# **Planning Commission Staff Report**

Project Type:	Sign Package
Meeting Date:	February 27, 2017
From:	Cecilia Hernandez Project Planner
Location:	North of I-64/US 40, and east of Boone's Crossing
Applicant:	Chesterfield Valley Nursery
Description:	<b>16825 N Outer 40 Rd (Chesterfield Valley Nursery) Sign Package</b> : A request for a Sign Package to establish sign criteria for the Chesterfield Valley Nursery for a 76.7 acre tract of land located north of I-64/US 40, and east of Boone's Crossing.

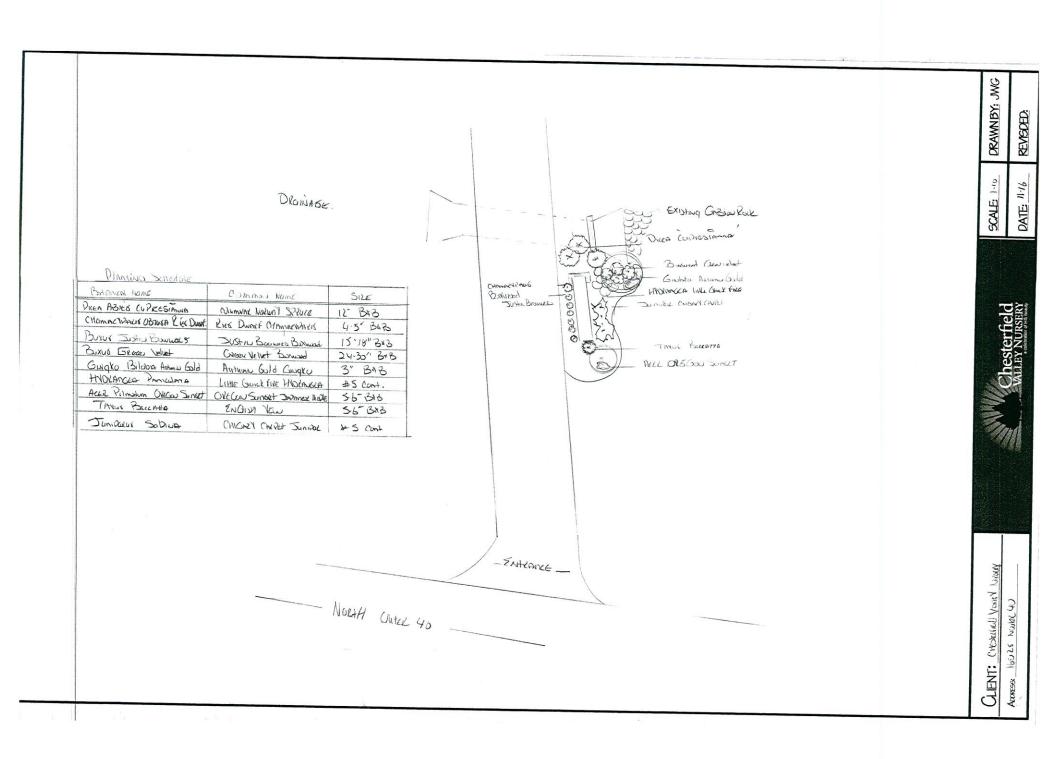
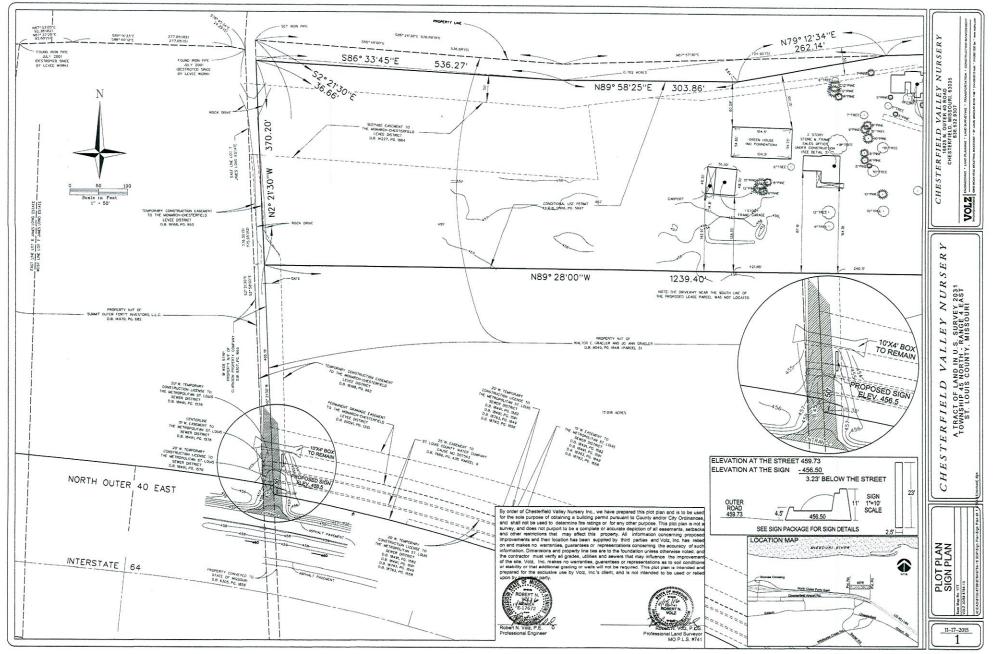
We are proposing a freestanding business sign, per the drawing submitted, with a few items that deviate from the requirements and will require approval from the Planning Commission per SEC. 04-05 C. We are proposing the total outline per sign face of 65.7 square feet varying from the standard 50 square feet maximum allowed. Additionally, we are proposing an 8' sign height with a monument portion reaching 11' in height varying from the allowed 6' high established at 50' front yard setback.

Our reason for this request is simple. Due to the grade of the land from 64/40, at 6', we feel the sign would not be visible from the highway or from a reasonable distance. Other signs in the vicinity are clearly higher with more sq. ft. For example, the Hardee's IcePlex sign appears to be larger in both sq. ft. and height.
